# Product Change Notification (PCN)

PCN #: 11A-2022

Nov 1, 2022

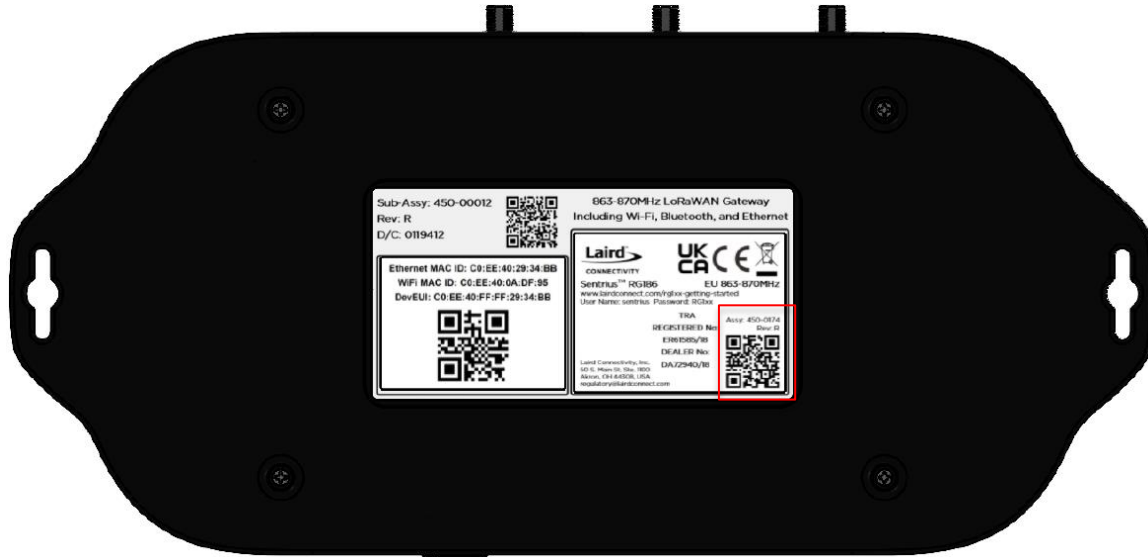
- Specific Part Number Changes: 450-00107-K2
- Added Additional LTE Antenna Port

- GA 6.2 FW update for Sentrius Gateways
- Meet Carrier LTE Compliance
